LEAK OF RADIOACTIVE LIQUOR IN THE FEED CLARIFICATION CELL AT BNG THORP SELLAFIELD

REVIEW OF THE MANAGEMENT AND TECHNICAL ASPECTS OF THE FAILURE AND ITS IMPLICATIONS FOR THE FUTURE OF THORP

CLIENT: GREENPEACE INTERNATIONAL

REPORT REF N° R3123-A2

Accountancy Tank B – Nozzle Failure

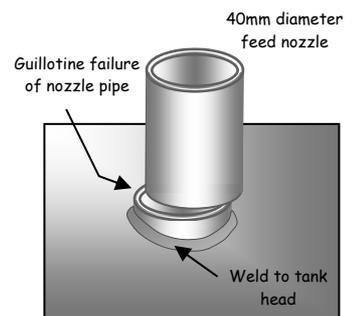
Following the detection of the leak, an internal BNG Board of Inquiry reported in May 2005² states that remote cctv inspection of Cell 220 revealed a significant quantity of dissolver liquor in the base of the cell and that a feed pipe to one of the accountancy tanks (Tank B – nozzle N5) had failed by fatigue fracture at a location close to the head of the vessel.

The failure of the feed nozzle is in the form of a complete guillotine break of the 40mm diameter feed pipe just above the pipe to tank welded joint, with the disconnected pipe remaining slightly misaligned above the stub of the pipe. Because of this alignment, the gravity flow of the clarified feed liquor continued to run into the tank, with some of the flow splashing out and running down the tank side, spilling onto sections of the supporting steel frame.

iii) By-Pass Both Accountancy Tanks A & B

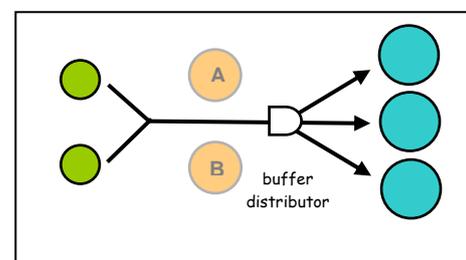
In this option, both accountancy tanks (A and the damaged B) are by-passed with the centrifuged or clarified liquor being fed to any one of the three downstream buffer tanks, with the bypass piping either feeding by gravity or being pumped to the existing buffer tank distributor.

To bypass the remaining accountancy tank (iii) requires remote installation of new pipework directly from the centrifuge, either gravity fed or pumped to the buffer tanks, with the former option possibly resulting in a 20 to 30% reduction of batch throughput because of the height limitations for gravity feeding in the cell.¹⁸ Removal of the accountancy tank process stage requires modification of the head-end process overall to introduce a new weighing stage¹⁹ and plutonium valency conditioning.¹

iv) Accountancy via Tank A Only

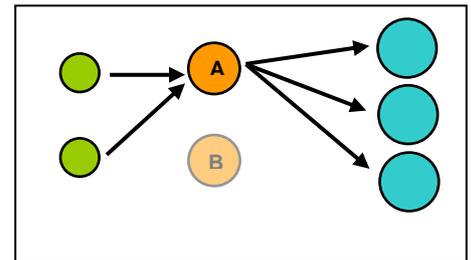
The use of just one accountancy tank would reduce THORP operational throughputs from in excess of 5 tonnes per day to 3 tonnes per day.

Even if the present continuous suspension mode for accountancy weighing is abandoned, further use of Tank A must be conditional on the fit-for-purpose condition of its nozzle and pipe connections. Before this option can proceed, these connections will have to be robotically inspected and subject to non-destructive examination. This is because Tank A has been in service and subject to the same conditions that failed the N5 connection to Tank B with at least the Tank A N5 connection being subject to the same number of sway and oscillatory fatigue cycles as its failed counterpart.²⁰

v) Tank A as Intermediate Stage Only

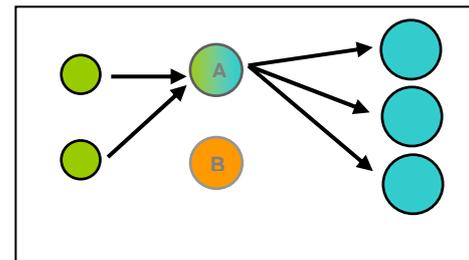
Tank A is utilised as a pump-through reservoir with accountancy being undertaken in the buffer tanks which enables the 5 tonne daily throughput to be maintained.

Tank A remains in use as a collecting and pump through reservoir, with accountancy being completed in the buffer tanks, thereby maintaining the 5 tonne daily throughput for THORP.

APPENDIX I – FRAME DAMAGE

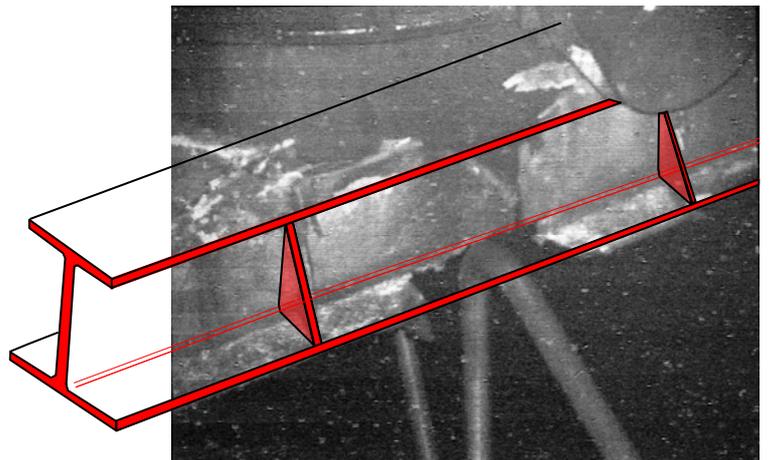
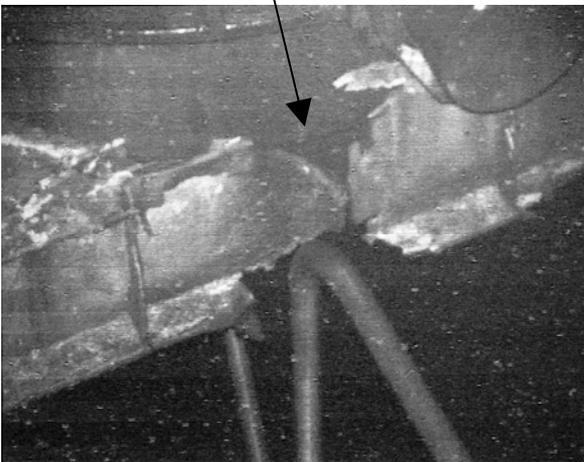
Over the period of the leak, perhaps for about 9 months, the carbon steel frame sustained significant corrosion, with the spilling nitric acid etching into and completely eroding through the higher and lower south sections of the frame, including the 600mm wide web of the main I-beam at the lower level.

The damage to the steel frame appears to be extensive⁷ and repairs, even if possible by remote means operating within the cell, would require opening up the cell access hole which is presently only 300mm diameter to receive new sections of the 600mm web I-beam.

- 21 For example and quite remarkably, the BNG report does not make reference to the condition of the steel framework being completely eroded through in places, even though this will present major problems for any recovery scheme.
